**REMARKS**

Claims 1-34 are pending in the above-identified application and have been rejected in the most recent Office Action. Claims 1 and 11 have been amended herein and new claims 35 and 36 have been added. The drawings have been amended to address and correct various respective informalities and the specification has been amended accordingly to accommodate the addition of the required new drawing. Applicants respectfully traverse each ground of rejection and request reconsideration and further examination of the application under 37 CFR § 1.111. Applicants respond to each ground of rejection and objection as follows.

FIG. 9

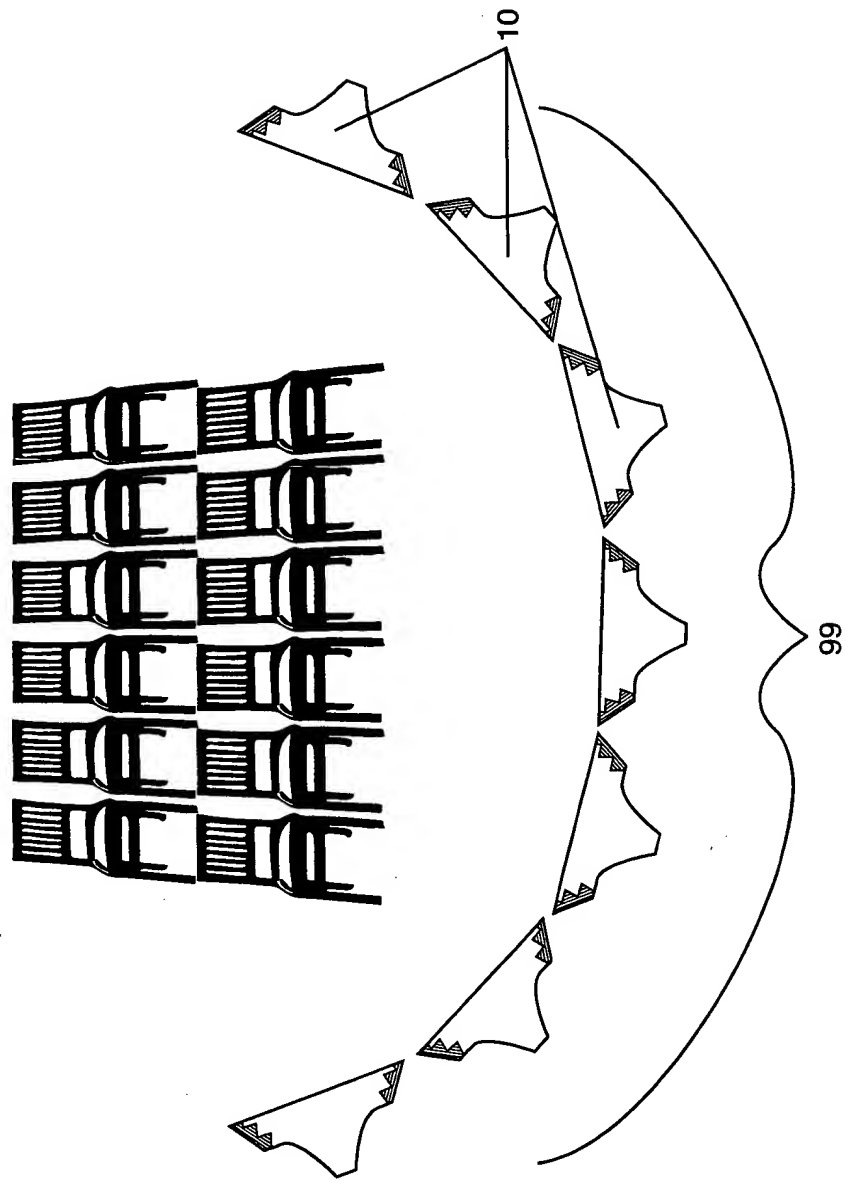
The drawings were objected to under 37 CFR 1.83(a) as not showing every feature of the invention specified in the claims, specifically the acoustic horn assemblies of claims 30-34. New drawing FIG. 9 was prepared to illustrate the acoustic horn assemblies as claimed in claims 30-34 and is submitted herewith. The specification has been amended to refer to new drawing FIG. 9 in the Brief Description of Drawings section and elsewhere. It is believed that new FIG. 9 overcomes the foregoing objections and that no new matter has been added. Thus, it is respectfully submitted that the drawings are no longer objectionable.
